Access Compliance Report

Public Rights-of-Way

Intersection ID: 12355	Main Street: MONUMENT_ST	Cross Street: GREENLAND_AV	Location: SW
ADA ID: EE57126251C8	Ramp Type: Perp	Initial Pass/Fail: Fail	Overall Compliance: No
		Severity Score: 8.75

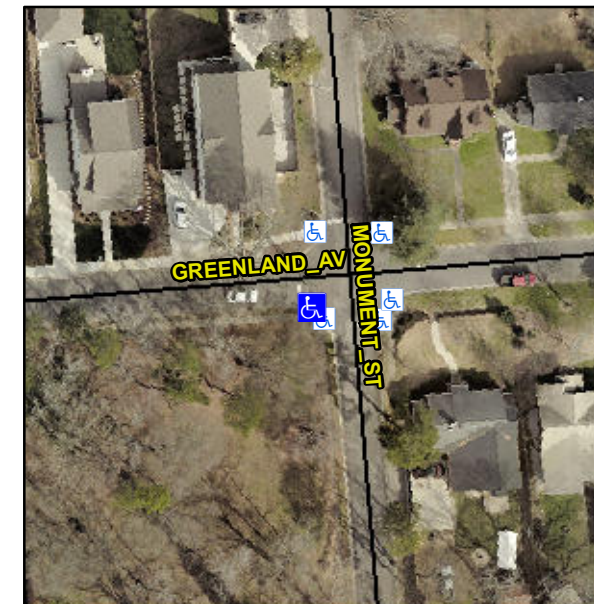
Not Found, R304.5.1

Compliance	Description	Data	Compliance	Description	Data
N/A	Ramp Length (in)	85.0	Yes	Ramp Slope (%)	5.0
No	Ramp Width (in)	47.0	Yes	Ramp XSlope (%)	0.3
N/A	Flare Type LT	N/A	N/A	Flare Type RT	N/A
N/A	Flare Slope LT (%)	N/A	N/A	Flare Slope RT (%)	N/A
N/A	Flare Traversable LT?	N/A	N/A	Flare Traversable RT?	N/A
N/A	Landing Length (in)	N/A	N/A	DWS Provided?	N/A
N/A	Landing Width (in)	N/A	N/A	DWS Contrast?	N/A
N/A	Landing Slope (%)	N/A	N/A	DWS Length (in)	N/A
N/A	Landing X Slope (%)	N/A	N/A	DWS Full Width?	N/A
N/A	Landing Curb? (Y/N)	N/A	N/A	DWS Offset (in)	N/A
N/A	Shared Landing?	N/A			
N/A	Gutter Ponding?	N/A	N/A	Gutter Slope (%)	N/A
N/A	Gutter Lip Ht (in)	N/A	N/A	Gutter X Slope (%)	N/A
N/A	Painted X Walk1?	No	N/A	Painted X Walk2?	N/A
	X Walk 1 Direction	To N		X Walk 2 Direction	N/A
N/A	X Walk 1 Width (in)	N/A	N/A	X Walk 2 Width (in)	N/A
	X Walk 1 Slope (%)	2.3		X Walk 2 Slope (%)	N/A
	X Walk 1 X Slope (%)	1.5		X Walk 2 X Slope (%)	N/A

Remove & Replace Entire Ramp.
